Access Compliance Report

Public Rights-of-Way

Intersection ID: 46488	Main Street: LAUDER_CT	Cross Street: BALLYBAY_DR	Location: NW
ADA ID: FA5D78F4BBF7	Ramp Type: BlendTrans1	Initial Pass/Fail: Fail	Overall Compliance: No
Severity Score: 12.5			
Codes/Mitigation Info/Possible Solution		Field Measurements/Component Compliance

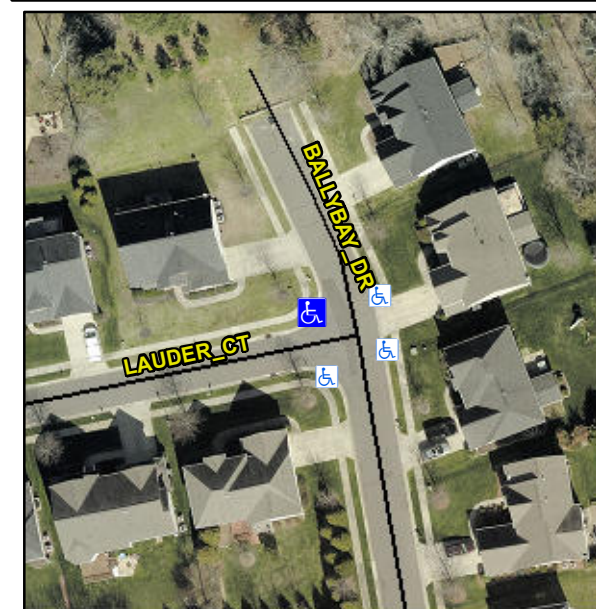
Remove & Replace Curb Ramp With Two New Directional Ramps or Equivalent.

R304.5.3

Compliance	Description	Data	Compliance	Description	Data
N/A	Ramp Length (in)	49.0	Yes	BlendTrans Slope (%)	2.7
Yes	Ramp Width (in)	48.0	No	BlendTrans XSlope (%)	5.1
N/A	Flare Type LT	N/A	N/A	Flare Type RT	N/A
N/A	Flare Slope LT (%)	N/A	N/A	Flare Slope RT (%)	N/A
N/A	Flare Traversable LT?	N/A	N/A	Flare Traversable RT?	N/A
N/A	Landing Length (in)	N/A	N/A	DWS Provided?	N/A
N/A	Landing Width (in)	N/A	N/A	DWS Contrast?	N/A
N/A	Landing Slope (%)	N/A	N/A	DWS Length (in)	N/A
N/A	Landing X Slope (%)	N/A	N/A	DWS Full Width?	N/A
N/A	Landing Curb? (Y/N)	N/A	N/A	DWS Offset (in)	N/A
N/A	Shared Landing?	N/A			
N/A	Gutter Ponding?	N/A	N/A	Gutter Slope (%)	N/A
N/A	Gutter Lip Ht (in)	N/A	N/A	Gutter X Slope (%)	N/A
N/A	Painted X Walk1?	No	N/A	Painted X Walk2?	No
	X Walk 1 Direction	To SE		X Walk 2 Direction	To NE
	X Walk 1 Width (in)	N/A		X Walk 2 Width (in)	N/A
	X Walk 1 Slope (%)	3.1		X Walk 2 Slope (%)	6.5
	X Walk 1 X Slope (%)	6.5		X Walk 2 X Slope (%)	1.2
